UNITED STATES PATENT AND TRADEMARK OFFICE

APPLICATION NO.	FILING DATE	FIRST NAMED INVENTOR	ATTORNEY DOCKET NO.	CONFIRMATION NO.
10/779,451	02/13/2004	Brenda Lee Bailey	19948-17041	8964

Office Action Summary	Application No. 10/779,451	Applicant(s) BAILEY, BRENDA LEE	
	Examiner Michael G. Bogart	Art Unit 3761

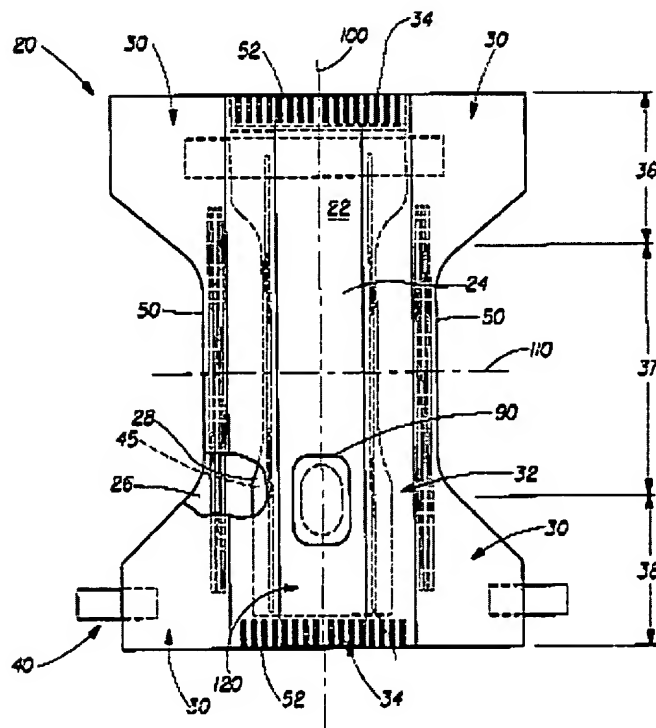
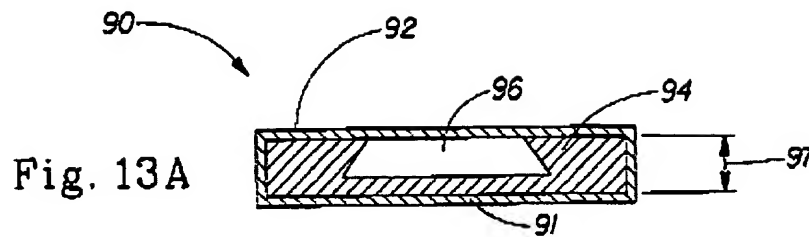
a feces receiver (bodily waste activation device) (90), connected to said center portion (37) by an opening (96) in said center portion (37);

wherein said feces receiver (90) lies proximate said outward facing surface (26);

wherein said feces receiver (90) is bounded by said opening (96), a chamber interior side wall, and a chamber interior bottom wall;

wherein said side wall includes an undercut, so that the cross sectional area of said feces receiver interior chamber increases proceeding from said opening (96) toward said bottom wall, and structural support elements (94) proximate said side wall having sufficient strength to prevent the collapse of said feces receiver (90) under the weight of said user (column 38, lines 6-10)(see figures 12 and 13A, below).

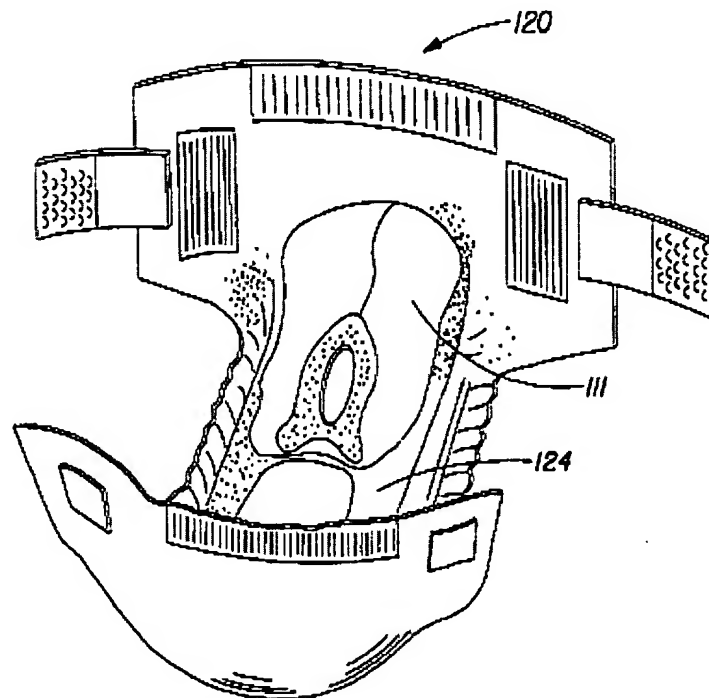
Regarding claim 2, Roe *et al.* teach that the rear belt (38) has a first rear wing (30) and a second rear wing (30);

said rear belt (38) includes closure means (40) located proximate said first rear wing (30) and said second rear wing (30);

said front belt (36) has a first front wing (30) and a second front wing (30); and

said front belt (36) includes closure means located proximate said first front wing (30) and said second front wing (30)(see figure 6, below).
